To: Planning Committee
 From: Jean Lamontagne
 Director of Development
 Re: Application by Matthew Cheng MAIBC for Rezoning at 8400 and 8440 Cook Road and 6571 Eckersley Road from Townhouse District (R2) and Single-Family Housing District, Subdivision Area E (R1/E) to Comprehensive Development District (CD/178)

to Planning - Dec. 05, 2006
 Date: November 22, 2006
 RZ04-267994
file: 12-8000-20-8141/8166

Staff Report

CONTEXT PLAN

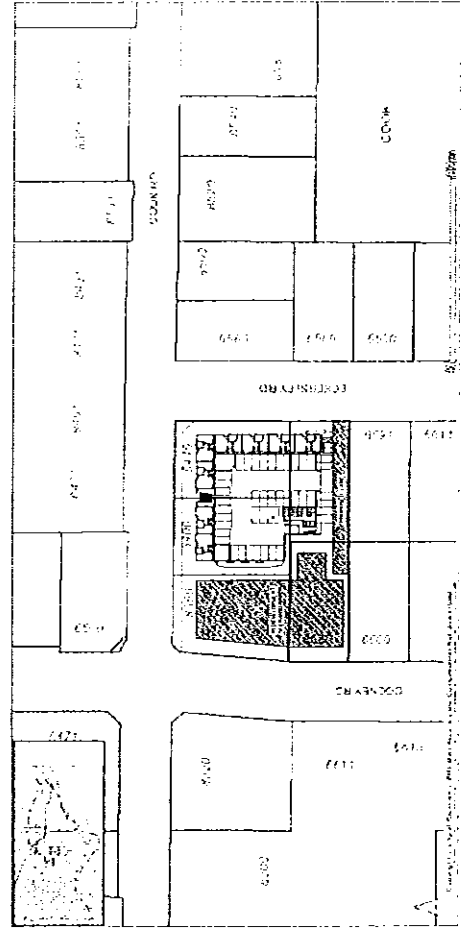
- The Context Plan (see **Attachment 2, Sheet D1**) illustrates a possible re-development scenario for the two parcels to the west, when consolidated.

- Prior to DP Application, the architect should meet with Building/Permits to ensure code issues fully scoped for action from outset.
- Provide redevelopment scenario for consolidated properties at 8360 Cook Rd and 6580 Cooney Rd required to indicate possible future context for the rezoning proposal.

Name: _____
 STREETSCAPES

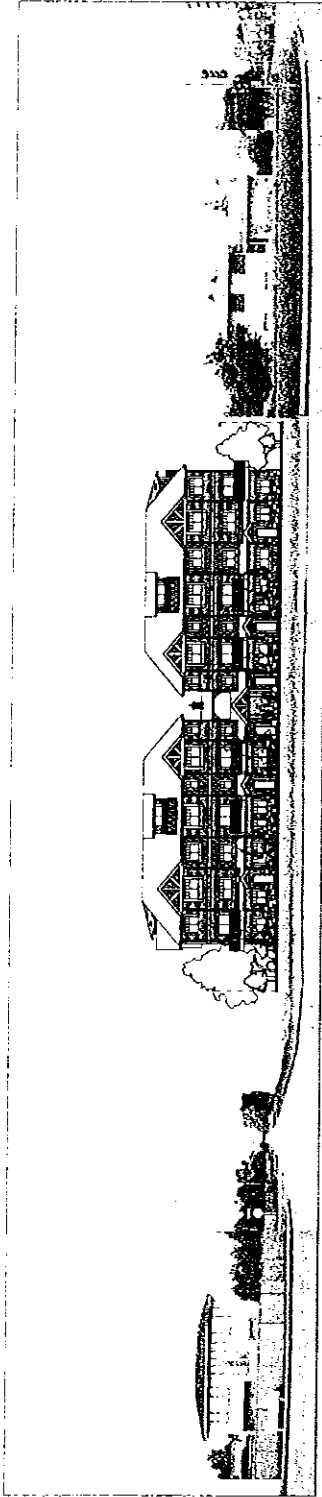
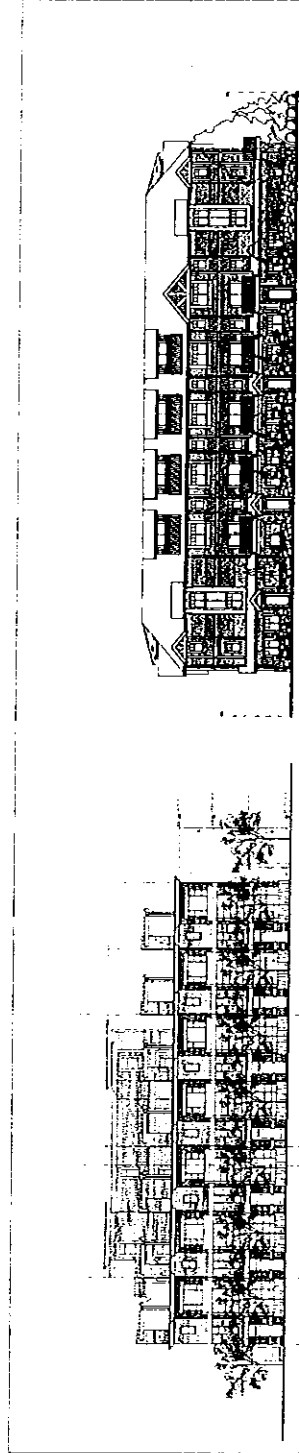
- Provide accurate streetscape context information presenting all adjacent buildings to accurate scale and to demonstrate appropriate interface and transition of building height and massing.
